ALBERT SO SURVEYORS LTD.

**Application for Permission under Section 16 of the Town Planning Ordinance (Cap.131)
For Minor Relaxation of Building Height Restriction from 2 Storeys to 4 Storeys
For a Proposed 4-Storey Columbarium (“the Proposed Development”)
At Part of Inland Lot No. 7755 RP and Government Land
sandwiched between Inland Lot Nos. 7755 RP and 7713 (altogether “the Site”)
Cape Collinson Road, Chai Wan, Hong Kong
(Planning Application No. A/H20/200)**

Supplementary Information

FIGURE 2.3 THE SURROUNDING OF THE SITE

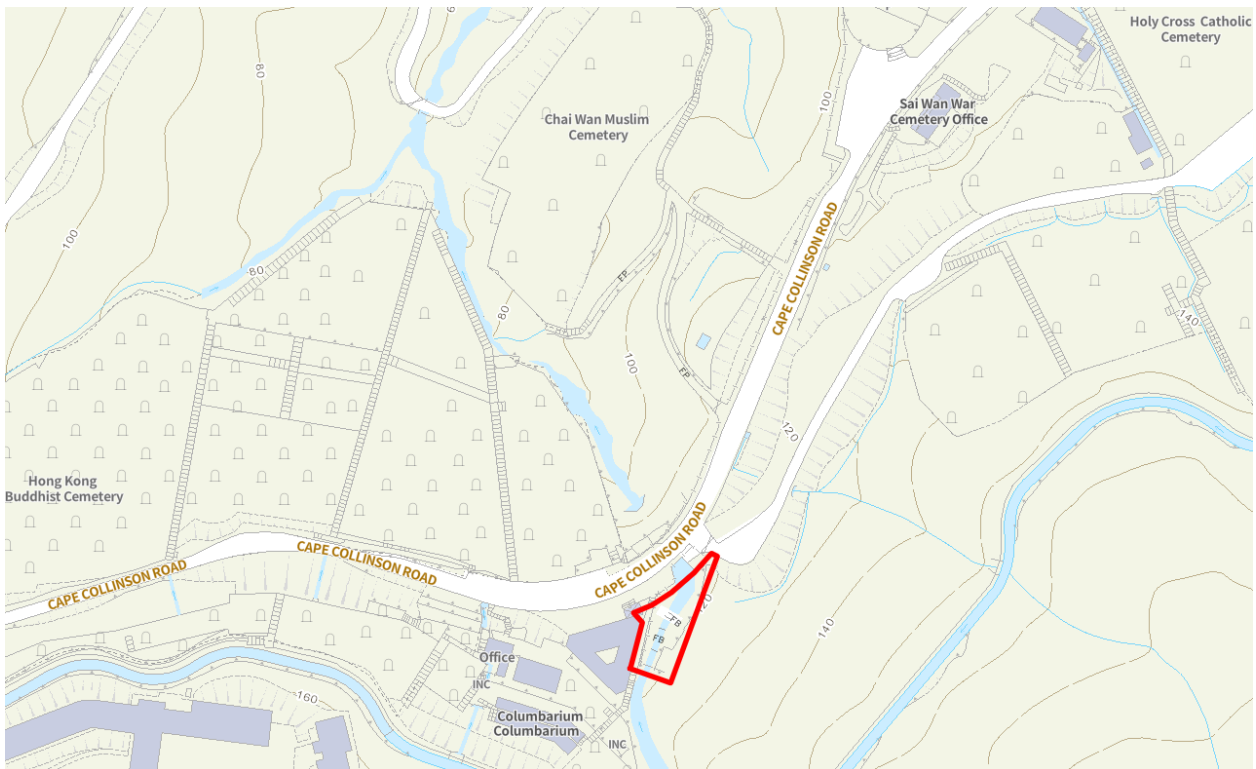
- iii. Section 2.4 of the Supporting Planning Statement is updated. Page 8 of the Supporting Planning Statement
- iv. Section 2.1.2 and Table 4.6 of the Traffic Impact Assessment Report are updated. Pages 2 and 13 of the Traffic Impact Assessment Report
- v. Section 3.2 of the Sewerage Impact Assessment Report is updated. Page 2 of the Sewerage Impact Assessment Report

2.5 The surrounding of the Site (outlined in red) is illustrated on the map at **Figure 2.3** below for reference.

- To the immediate north of the Site: Chai Wan Muslim Cemetery.
- To the immediate west and northwest of the Site: Hong Kong Buddhist Cemetery managed by the Applicant consists of columbaria and cemeteries, providing a total of about 11,400 niches and graves (including about 7,500 niches, of which about 90% are occupied, and about 3,900 graves).
- To the immediate east of the Site: Holy Cross Catholic Cemetery.
